SUBJECT: AMENDMENT NO. 112 TO PROVISIONAL OPERATING LICENSE NO. DPR-20: STEAM GENERATOR AUGMENTED INSERVICE INSPECTION PROGRAM (TAC NO. 56365)

PALISADES PLANT

Amendment No. 112
License No. DPR-20

SAFETY EVALUATION BY THE OFFICE OF NUCLEAR REACTOR REGULATION
RELATED TO AMENDMENT NO. 112 TO PROVISIONAL OPERATING LICENSE NO. DPR-20

FIGURE 4.14.1 - SUPPLEMENTARY SAMPLING FLOW CHART

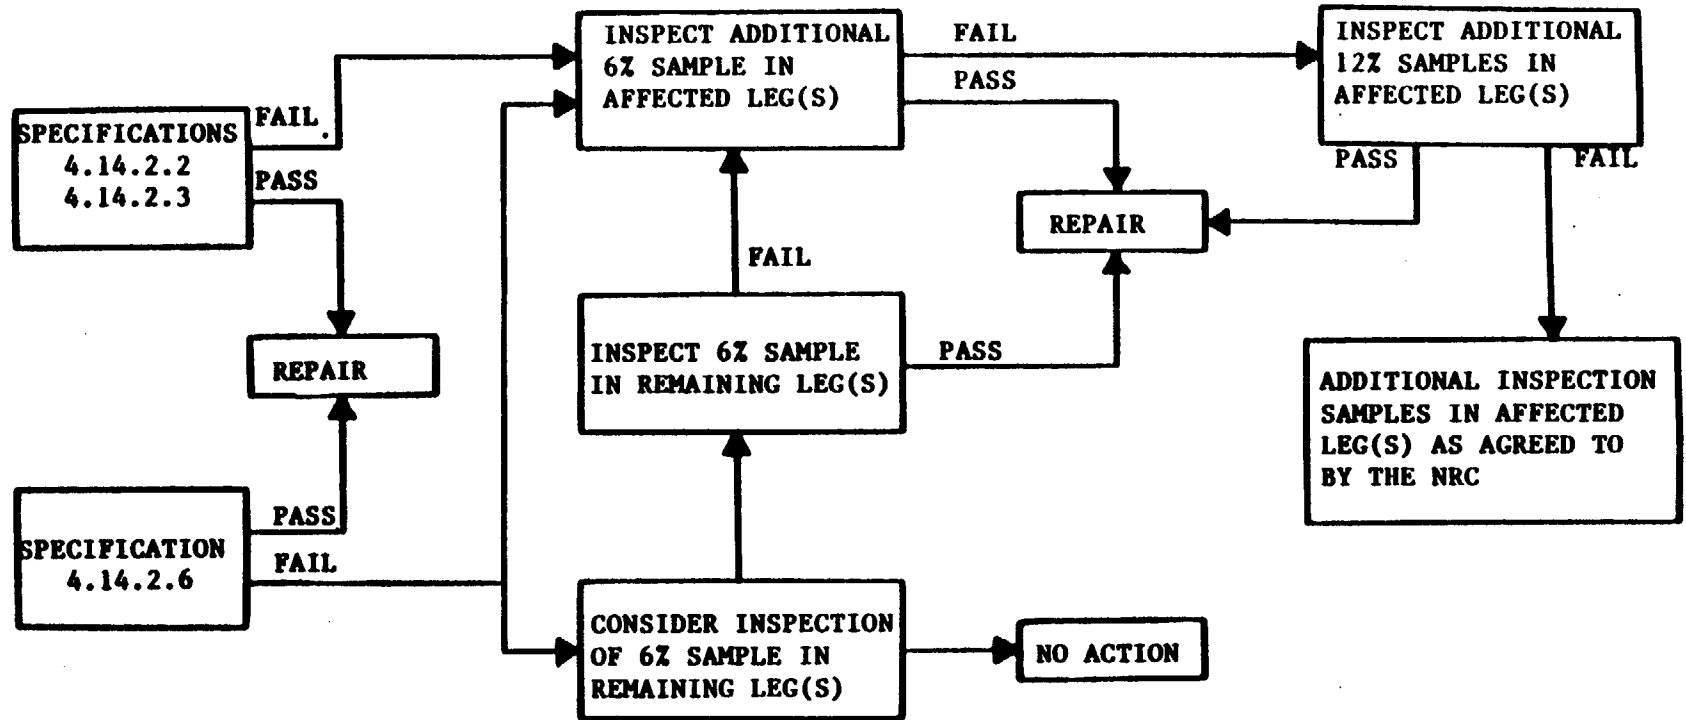
This section adds a proposed new requirement; namely should initial inspection sampling in accordance with Sections 4.14.2.2, 4.14.2.3, or 4.14.2.6 yield results exceeding one or more of the following criteria, then supplementary samples of unplugged tubes shall be inspected in accordance with Figure 4.14.1.

- a) More than 10% of the inspected tubes in a leg have detectable wall degradation (greater than or equal to 30% through wall) where no previous degradation was detected.
- b) More than 10% of the inspected tubes in a leg exhibit further wall degradation (greater than a 10% increase in through wall degradation).
- c) More than 1% of the inspected tubes in a leg have indications of tube wall degradation in excess of the repair criteria of Specification 4.14.4 where no wall degradation greater than 30% was detected in the previous two inspections.

In the event that one or more of the above criteria are exceeded during initial inspection sampling, Figure 4.14.1 would require that an additional 6% sample of tubes be inspected. If the results of the second sample exceed the above criteria, then an additional 12% sample would have to be inspected. If the results of this third sample exceed the above criteria, then additional inspection samples must be performed as agreed to by the NRC.

The current Technical Specifications for Palisades contain no requirements for supplementary sample inspections. The supplementary sampling requirements now being proposed are still less stringent than what is specified in the Technical Specifications for virtually all other plants. The staff finds this not to pose any immediate concern since corrosion degradation has been largely arrested since the 1970s. Given the current status of corrosion degradation in the Palisades steam generators the staff believes the Technical Specification

The above comments notwithstanding, the proposed supplementary sampling requirements in Section 4.14.3.1 represent an upgrade of existing requirements and are therefore acceptable to the staff.
